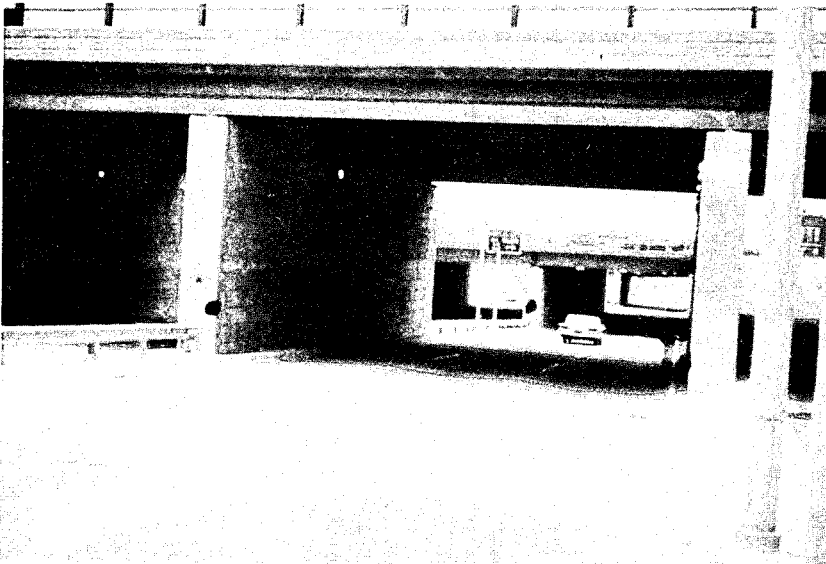
Now, this is a brand new section of an interstate highway. Here on the left the guardrail is installed wrong because you can slide right into the abutment. Notice there are three structures in this one picture.

Here is a close-up view of something we were just talking about. You see the fence in between there; the material is there to provide a smooth-sliding action. Someone wasn't thinking; there is a tapered curb there and there happens to be a little turn, and because of that someone is going to have to get wiped out in that spot.
